UNITED STATES PATENT AND TRADEMARK OFFICE

APPLICATION NO.	FILING DATE	FIRST NAMED INVENTOR	ATTORNEY DOCKET NO.	CONFIRMATION NO.
10/783,812	02/20/2004	Barry Gammon	GAM-001CON	7060

Office Action Summary	Application No. 10/783,812	Applicant(s) GAMMON, BARRY 6D	
	Examiner Hadi Shakeri	Art Unit 3723

DETAILED ACTION

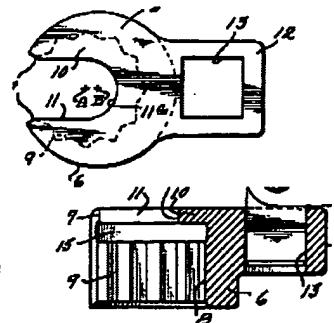
3. Claims 1 and 2 are rejected under 35 U.S.C. 102(b) as being anticipated by Johnson, US Patent No. 2,715,347.

Johnson discloses all the limitations, i.e., a socket having a center line (B) and a perimeter (Fig. 3), first face (bottom face as shown in Figs. 2 and 4), an opposite second face, and a receiving slot extending from the first face towards the second including a receiving region (8) adjacent to the

first face (first face separated from the second face by web 10) having a center line (A) offset from (B) and includes a step (defined by 10 or 15) against which the connection element rests during rotation of the socket body, and wherein the second face includes a port (13) that does not extend to the first face, having a center line that is not in alignment with the socket body positioned within the perimeter of the socket body.

Regarding claim 2, Johnson meets the limitations.

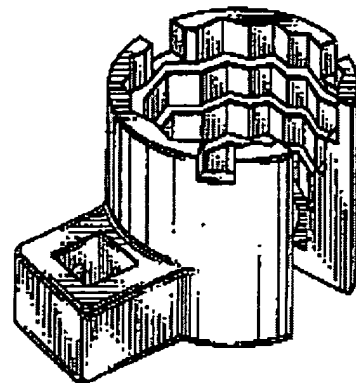
5. Claims 3-6 are rejected under 35 U.S.C. 103(a) as being unpatentable over Johnson in view of Farnan et al., US Patent No. Des. 376,521.

Johnson meets all the limitations of the claims except for stepped polygonal and rounded configurations, and wing slots. Farnan et al. teaches stepped polygonal configurations having wing slots. It would have been obvious to one of ordinary skill in the art, at the time the invention was made, to modify the invention of Johnson with the polygonal stepped configuration and wing slots as taught by Farnan et al. to adapt the tool for driving different sized fasteners and fasteners having wings.

Regarding the rounded configuration claim 5, It would have been obvious to one having ordinary skill in the art at the time the invention was made to make the receiving section rounded instead of polygonal for

wing nuts having rounded head, since it has been held that changing shape, dependent on work-piece parameters, involves only routine skill in the art. *In re Stevens*, 101 US PQ 284(CCPA1954).

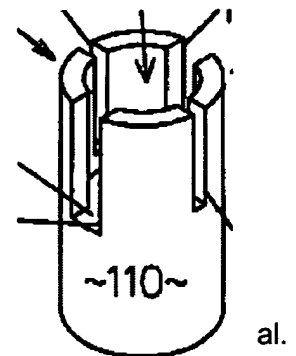
6. Claims 4, 5 are rejected under 35 U.S.C. 103(a) as being unpatentable over Johnson in view Makovsky et al., US Patent No. 5,697,268.

Johnson meets all the limitations of the above claims except for wing slots and rounded configurations. Makovsky et al. teaches wing nut driver having slots. It would have been obvious to one of ordinary skill in the art, at the time the invention was made, to modify the invention of Johnson with the configuration and wing slots as taught by Makovsky et al. to adapt the tool for driving fasteners having wings.

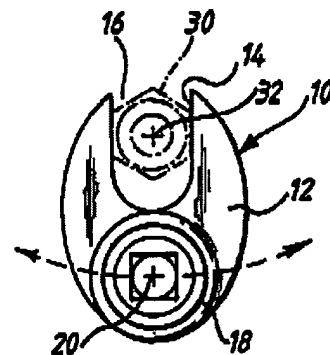
7. Claims 1-6 are rejected under 35 U.S.C. 103(a) as being unpatentable over Higgins (GB 2 266 257) in view Farnan et al.

Higgins meets all the limitations of the claim 1, i.e., a socket having a center line and a perimeter, first face and an opposite second face, and a receiving slot extending from the first face towards the second including a receiving region adjacent to the first face having a center line that is not in alignment with the centerline of the socket body (Fig. 1) and wherein the second face includes a port (24) that does not extend to the first face of the socket body, the port having a center line that is not in alignment with the center line of the socket body, except for a step against which the connection element rests during rotation of the socket body. Farnan et al. teaches stepped polygonal configurations having wing slots. It would have

been obvious to one of ordinary skill in the art, at the time the invention was made, to modify the invention of Higgins with the polygonal stepped configuration and wing slots as taught by Farnan et al. to adapt the tool for driving different sized fasteners and fasteners having wings.

Regarding claims 2-4 and 6, Higgins as modified by Foeman et al. meets the limitations.

Regarding the rounded configuration, claim 5, it would have been obvious to one having ordinary skill in the art at the time the invention was made to make the receiving section rounded instead of polygonal for wing nuts having rounded head, since it has been held that changing shape, dependent on work-piece parameters, involves only routine skill in the art. *In re Stevens*, 101 US PQ 284(CCPA1954).
